GEORGES COVE MARINA SITE – PP-2024-658

RE: GEORGES COVE MARINA PLANNING PROPOSAL – RESPONSE TO AGENCY COMMENTS FROM 15 APRIL 2025 MEETING

Table 1: Response to agency comments.

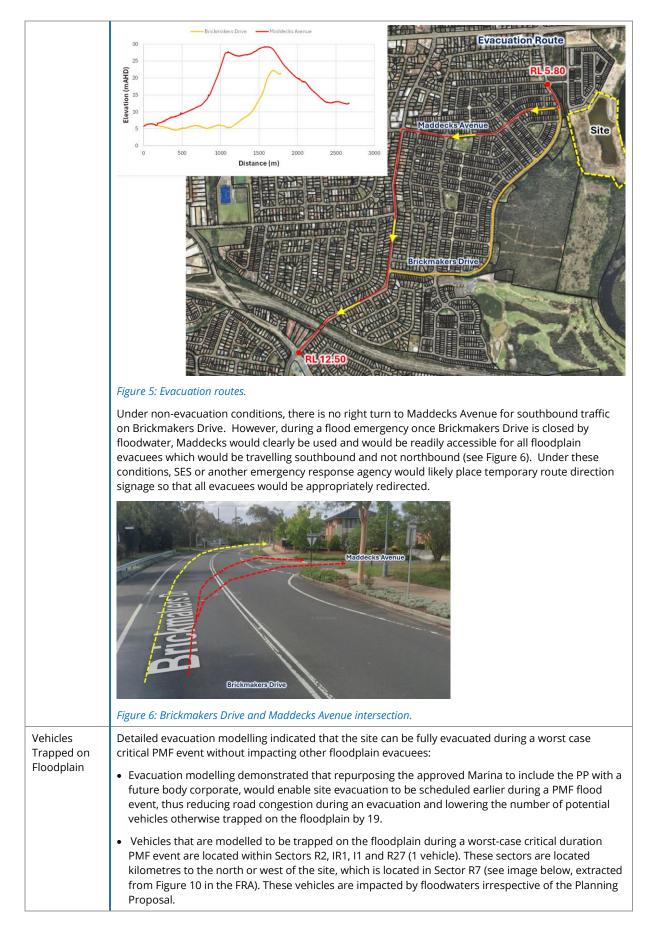
• Structural design : The urban superstructure and associated buildings will be structurally designed to resist flood forces up to the PMF. Flood forces will not be significant and can be readily accommodated.
Safe Building Construction	Many structures are commonly built in or over hazardous water bodies or areas subject to extreme flooding (bridges, wharfs, ocean oil rigs <i>etc</i>). Finger Wharf at Woolloomooloo on the Harbour (shown in Figure 3) is a very real and successful example of residential development located over H6 hazard conditions, regularly experiencing hazards arising from deep water, extreme tidal or flood flows, and wave action.

Figure 3: Finger Wharf residential development.
	Flood modelling included in the Flood Risk Assessment (FRA) prepared by Martens in March 2025 demonstrates that flood forces will be very low on supporting piers due to low velocities (< 1 m/s in the 5,000 year ARI flood which is not dissimilar to peak tidal flows in the harbour). High riverine velocities are not experienced within the urban area even under the most extreme PMF conditions. There is no credible impediment to constructing safe buildings at this site.
Minister's s9.1 Requirements	Section 4.1 of the FRA provides a comprehensive assessment of the PP against the Section 9.1 Local Planning Directions 4.1 Flooding, indicating that all provisions are met. In summary:
